LATE ITEMS ORDINARY MEETING

3 DECEMBER 2019

12.10 REQUEST FOR A NEGOTIATED DECISION FOR DEVELOPMENT PERMIT D-29-2019 FOR RECONFIGURING A LOT (TWO LOTS INTO SIX LOTS) LOCATED AT 535 BUNGUNDARRA ROAD AND LOT 100 BUNGUNDARRA ROAD, BUNGUNDARRA

File No: D-29-2019

Proposal Plan

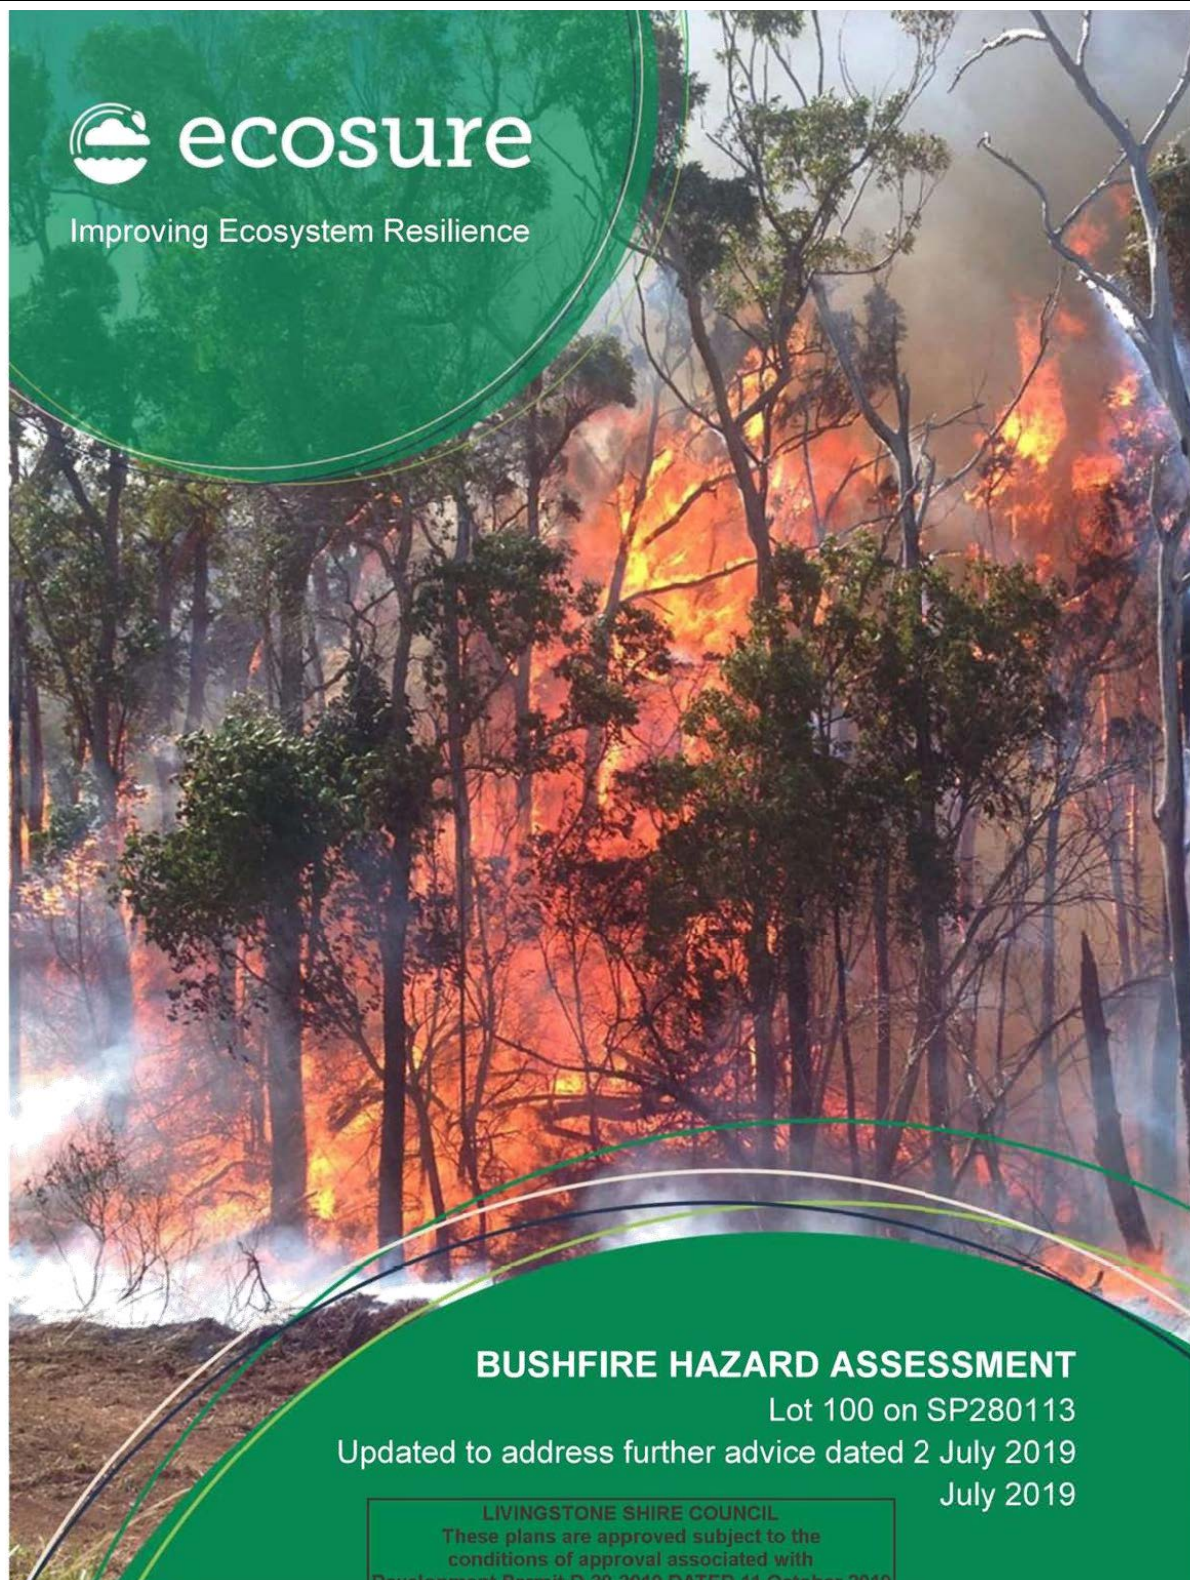
The representations include a revised proposal plan illustrating a proposed vegetation covenant over proposed Lot 2. It was agreed at the Council meeting that a covenant be applied to seventy (70) per cent of proposed Lot 2 and the covenant proposed covers 75.6 per cent. The representations (under condition 9.3(iii)) state that the boundary for proposed Lot 2 has been amended to take into the north-east corner of proposed Lot 4 and add the area we intended to be outside the covenant on proposed Lot 2, to proposed Lot 4.

Officers are amenable to the proposed boundary change between proposed Lots 2 and 4 to ensure the covenant is contained on one (1) allotment. It does not result in substantially different development.

It is recommended the amended plan be included as an approved plan and the condition be updated.
